APPENDIX C

Public Comments and Reponses

The Federal Aviation Administration (FAA) is evaluating Space Exploration Technologies Corporation's (SpaceX's) proposal to increase the launch and landing cadence of the Starship/Super Heavy launch vehicle at its existing Boca Chica Launch Site in Cameron County, Texas. SpaceX must obtain a new license or a license modification from the FAA in order to launch and land Starship and Super Heavy and to use associated launch systems at a higher cadence than analyzed in the 2022 *Final Programmatic Environmental Assessment for the SpaceX Starship/Super Heavy Launch Vehicle Program at the SpaceX Boca Chica Launch Site in Cameron County, Texas* (PEA; FAA 2022). FAA evaluated the potential environmental effects of the activities associated with the federal action of modifying SpaceX's vehicle operator license in a tiered environmental assessment (EA).

Fig. 1: North Pacific Starship landing area (Hawaii and central north Pacific landing area and northeast and tropical Pacific Ocean landing area). Illustration from the EA, page 11.

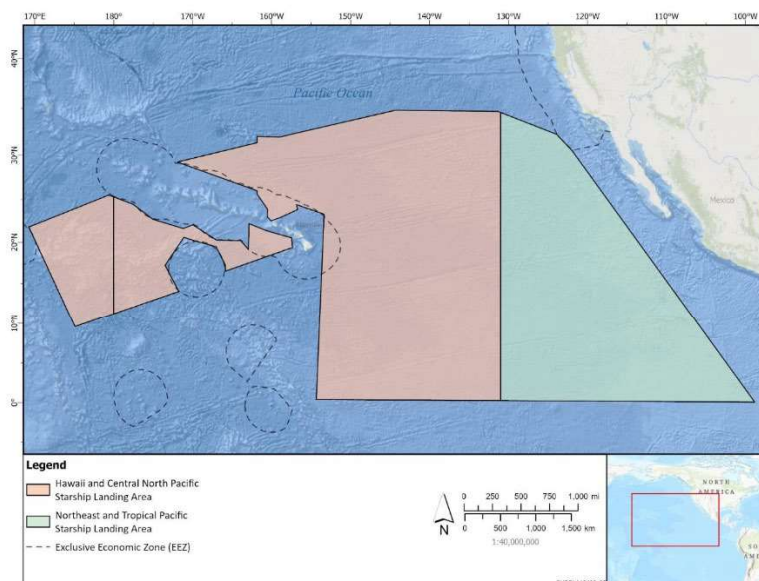
The Hawaii Department of Land and Natural Resources' Division of Aquatic Resources (DAR) appreciates the opportunity to comment on the Federal Aviation Administration's Revised Draft Tiered Environmental Assessment (EA) for SpaceX Starship/Super Heavy Vehicle Increased Cadence at the SpaceX Boca Chica Launch Site in Cameron County, Texas ([FAA-2024-2006](#)). DAR is concerned with the potential effects of landings near the main Hawaiian Islands and the northwest Hawaiian Islands.

According to the EA, the proposed action increases SpaceX flights to up to 25 “Super Heavy” landings and up to 25 “Starship” landings annually. Some of these vehicles may not be reused and up to 20 may instead experience:

In response to concerns raised by DAR and other commenters, the FAA revised the EA to remove the Pacific action area from the U.S EEZ and establish a 50 nautical mile buffer zone around the Papahānaumokuākea Marine National Monument. These changes will further reduce potential environmental impacts and ensure there will be no significant effects by:
